STATE OF DELAWARE
DEPARTMENT OF TRANSPORTATION
800 BAY ROAD
P.O. BOX 778
DOVER, DELAWARE 19903

February 17, 2009

DelDOT Contract Number: 95-090-01; Federal Aid Project Number: IM-N056(27)
I-95 Delaware Turnpike Improvements Project
I-95/SR 1 Interchange/I-95 Turnpike Mainline
Turnpike Mainline from SR 1 to SR 141; I-95/SR 1 Interchange; I-95 Northbound
Widening Extension
New Castle County, Delaware
Environmental Reevaluation [*Change in interchange design*]

PLAN LEGEND

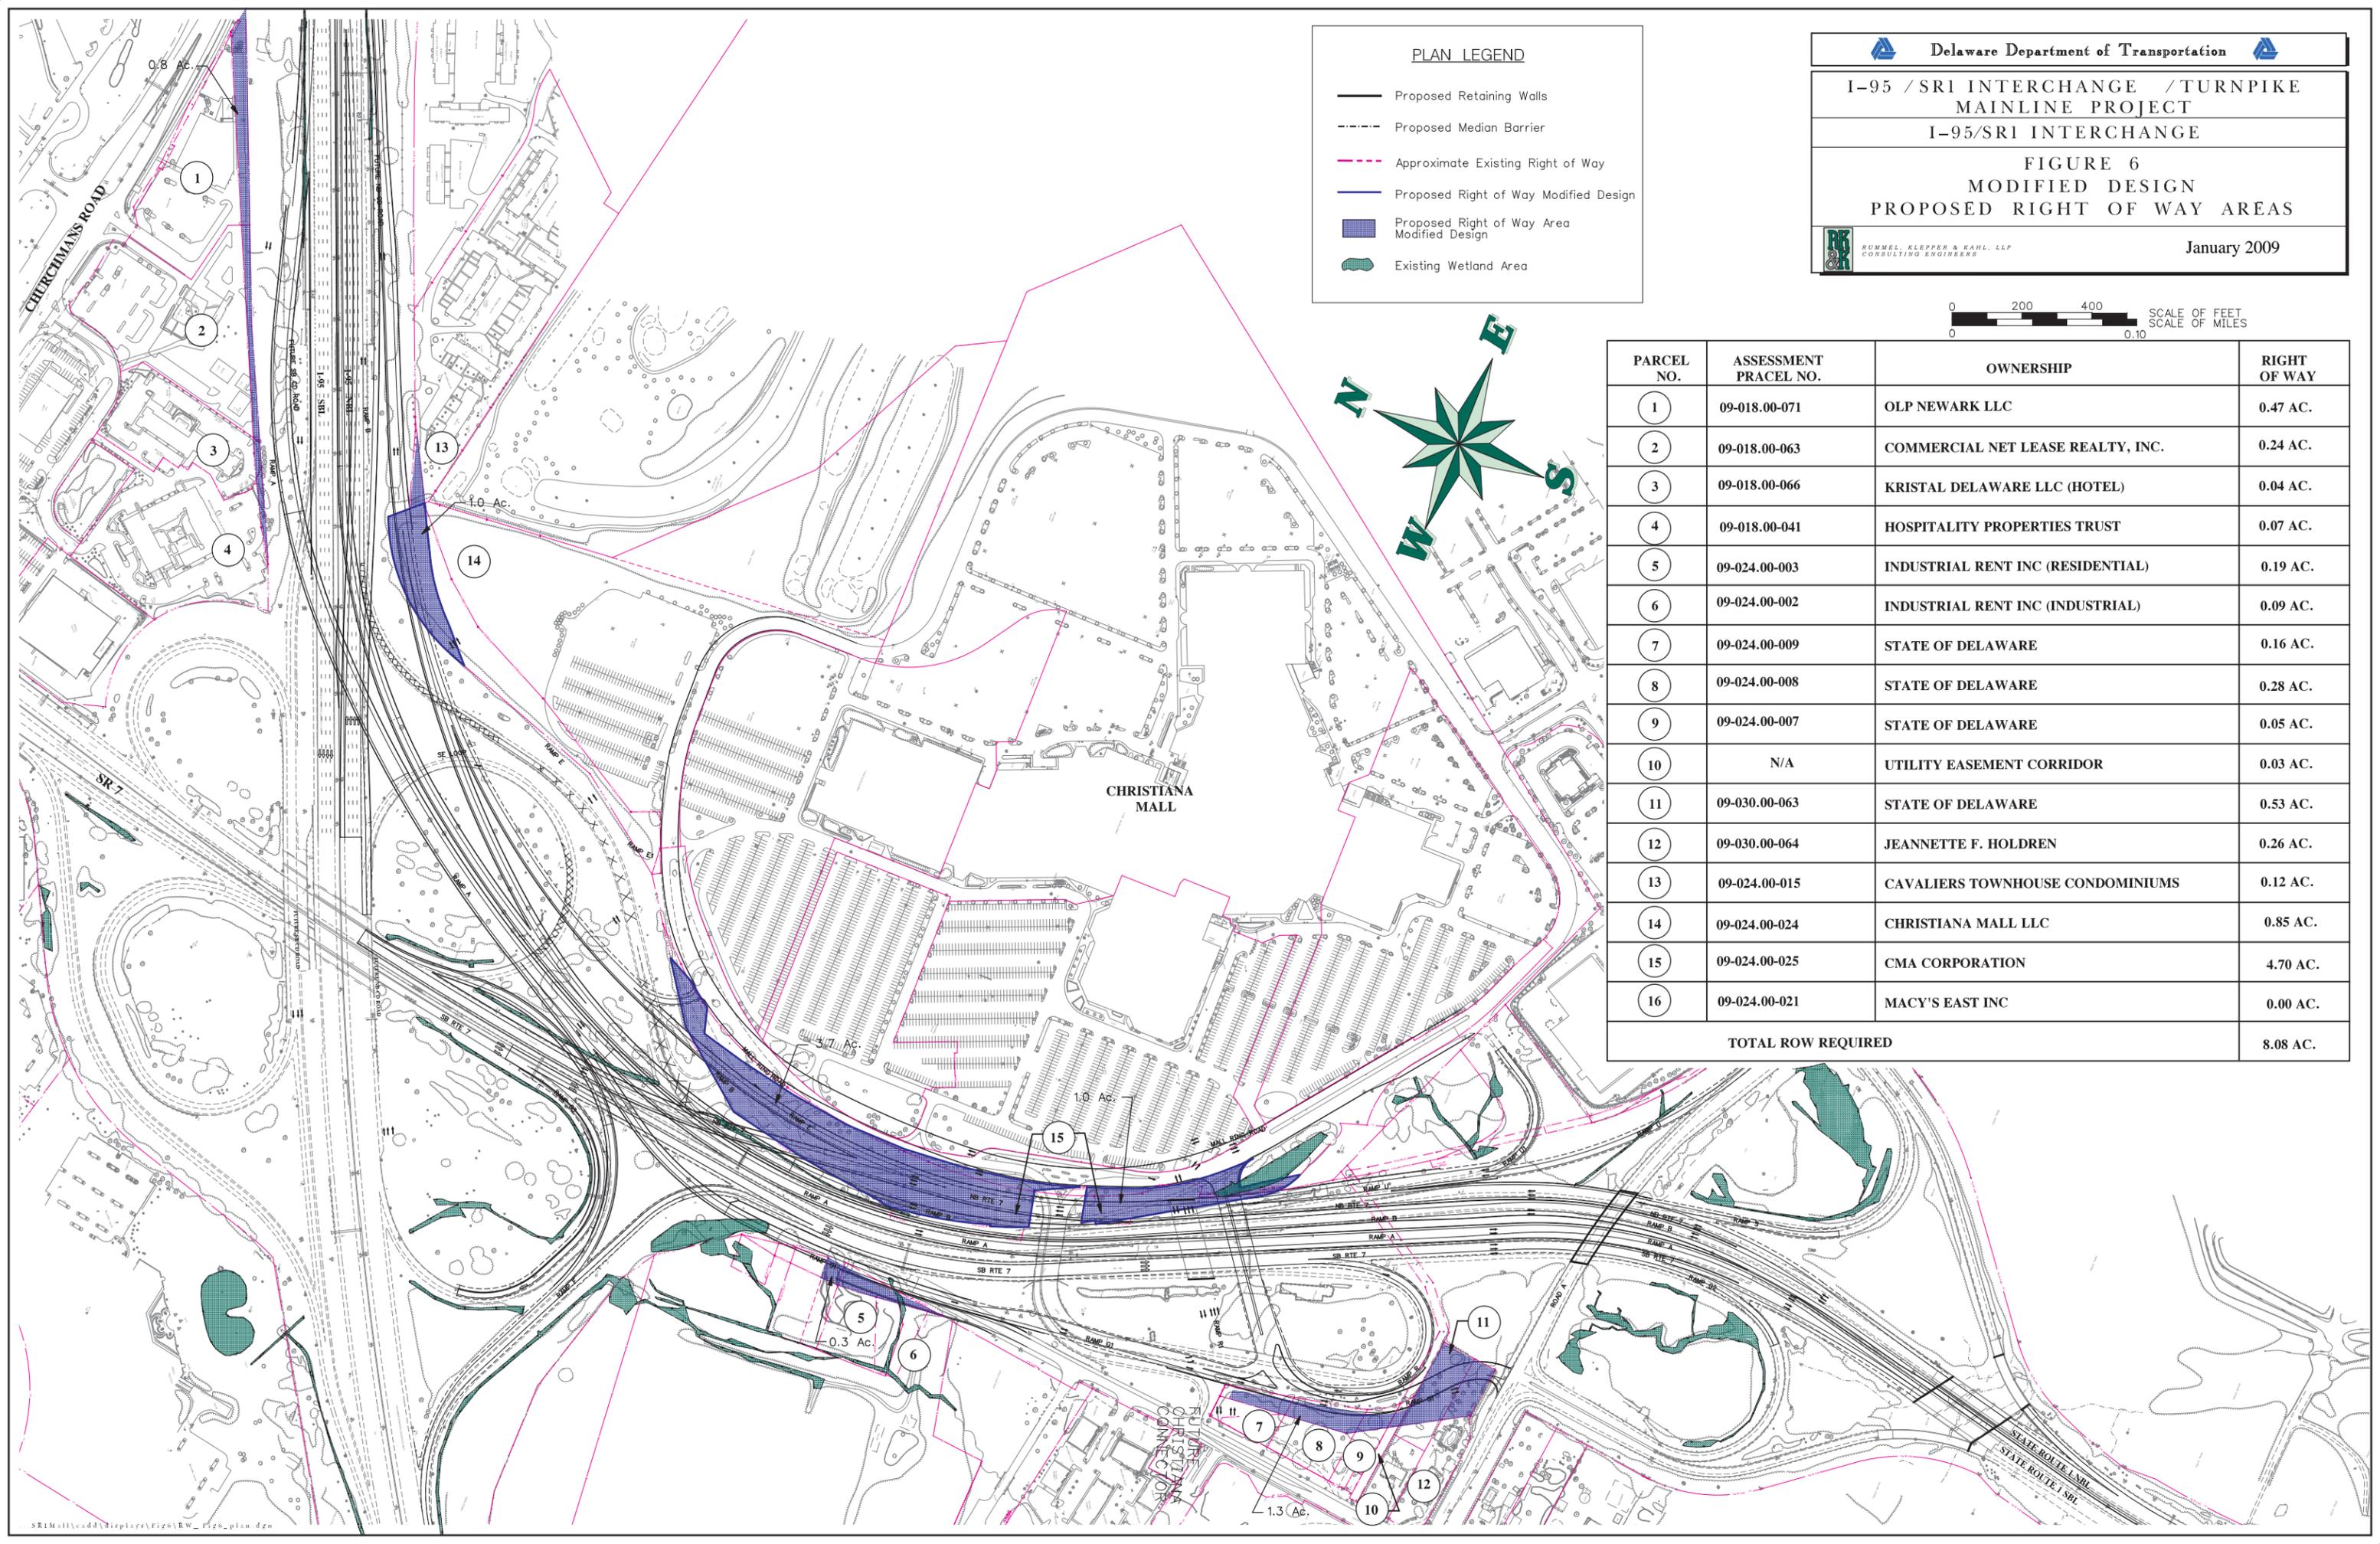
Potential property impacts resulting from the current design of the I-95/SR 1 interchange are shown on **Figure 6**. The modified design of the interchange will result in a total acquisition of 8.08 acres as compared to 9.41 acres proposed to be acquired in the FONSI design.

I-95 / SRI INTERCHANGE IMPROVEMENTS
 I-95 / SRI INTERCHANGE
COMPREHENSIVE WETLAND IMPACTS

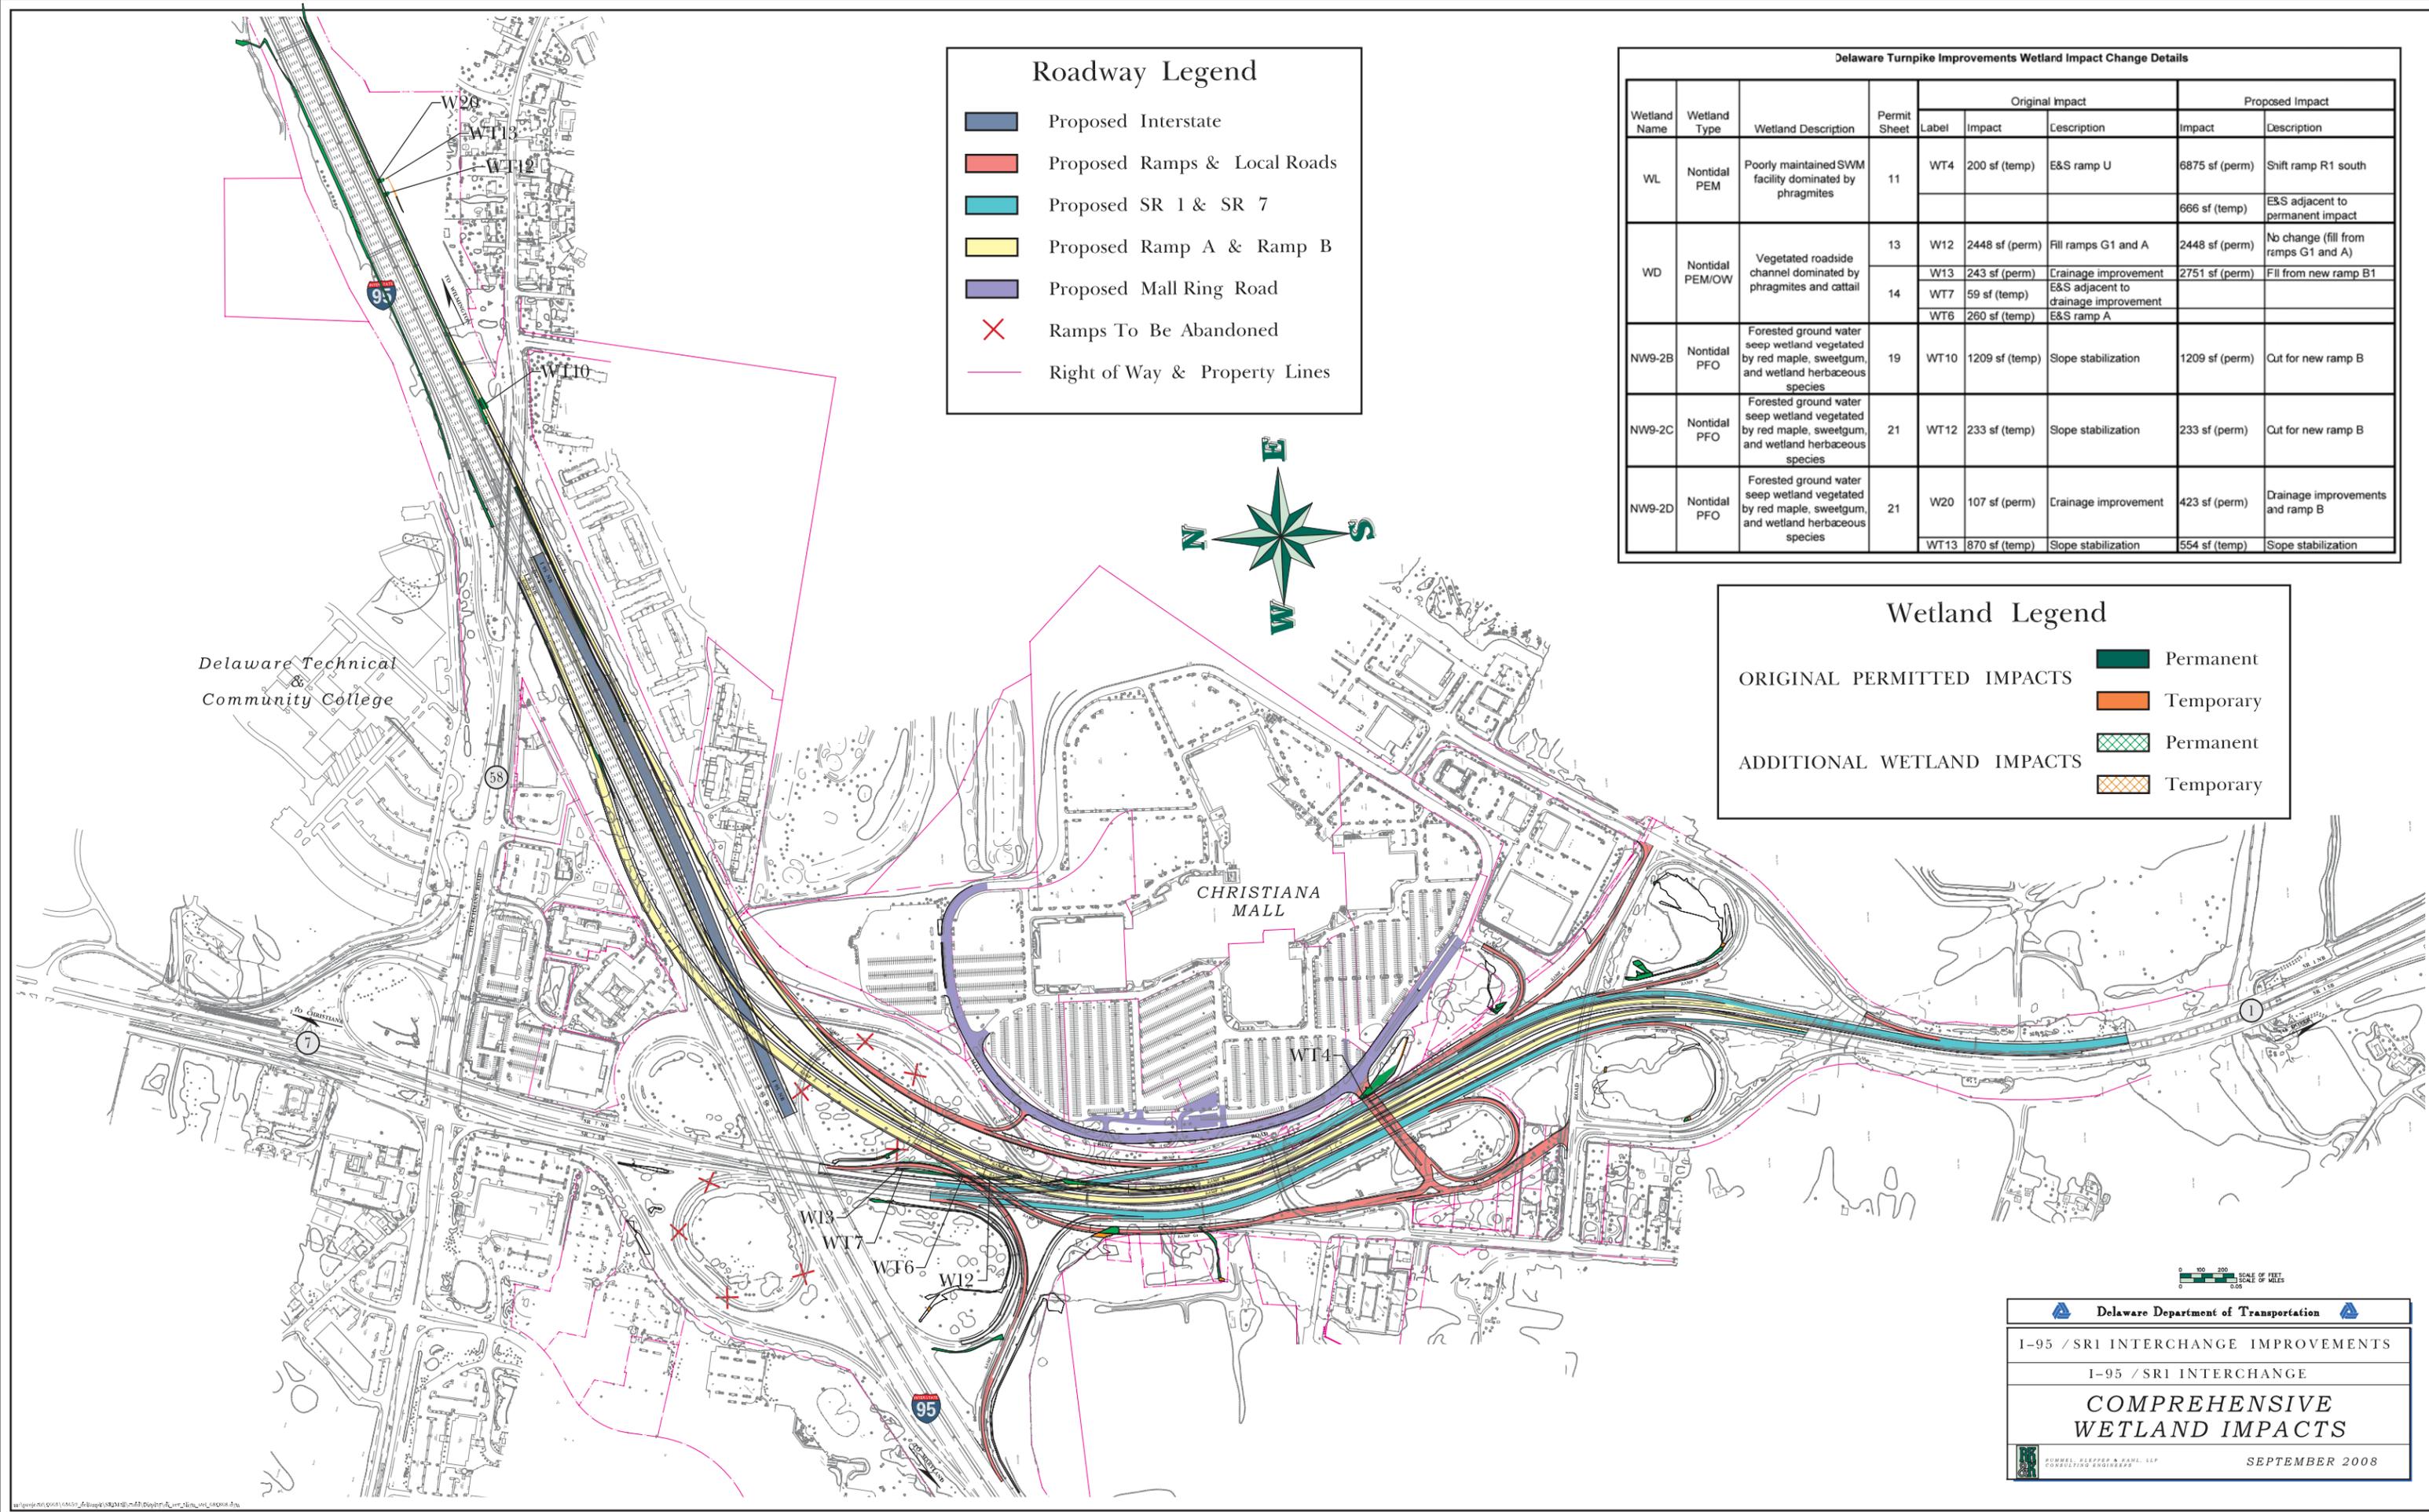
- Maps (4) showing the revised alignment, titled “Comprehensive Wetland Impacts” were handed out (attached) and large maps of the preliminary alignment, revised alignment and comprehensive wetland impact were displayed for discussion purposes.
- The preliminary design of the SR 1 Interchange included a NB SR1 to NB I-95 ramp that entered I-95 on the right. Traffic analysis indicates that 76% of the traffic making this movement needs to merge all the way to the left on I-95 to proceed north to the Wilmington area creating a dangerous weave on I-95. To eliminate this condition a split NB ramp is proposed that would allow Wilmington area traffic to enter I-95 on the left in a dedicated lane (becoming the 5th lane). Additionally, to avoid a “cattle shoot effect” of having merging traffic entering on both sides of I-95 at the same time,

- The existing NB I-95 to NB SR 7 movement is accomplished via a loop ramp following a weave on I-95. To eliminate this weave a semi-direct flyover ramp is proposed.
- Preliminary design included a flyover ramp to provide access to the Christiana Mall. To allow for adequate clearance over SR 1 this ramp has been shifted to the south a few hundred feet.

- The shift of the Mall access flyover will permanently impact an additional 6,875 square feet (0.16 acres) of emergent wetlands.
- In total, the design modifications will cause an additional 11,141 square feet (0.25 acres) of permanent impacts to wetlands and will reduce the total temporary impact to wetlands by 1,611 square feet (0.04 acres). *[After the meeting the additional impacts were calculated considering the three forested wetlands as total takes, the additional permanent impact is 11,863 square feet (0.27 acres) and the temporary impacts are reduced by 2,333 square feet (0.05 acres).]*

- *After the meeting, the mitigation ratios were applied to impacts that included the forested wetlands as total takes resulting in required mitigation of 55,676 square feet (1.28 acres).*
- DelDOT proposed that no additional mitigation was required since the required mitigation for the project is less than the mitigation provided for the project
- ACOE agreed that no additional mitigation would likely be required for the project. Further ACOE stated that no permit actions would be taken on this issue until a permit modification was requested by DelDOT. DelDOT should request this modification when plans and details of the SR1 phase of the project are available.
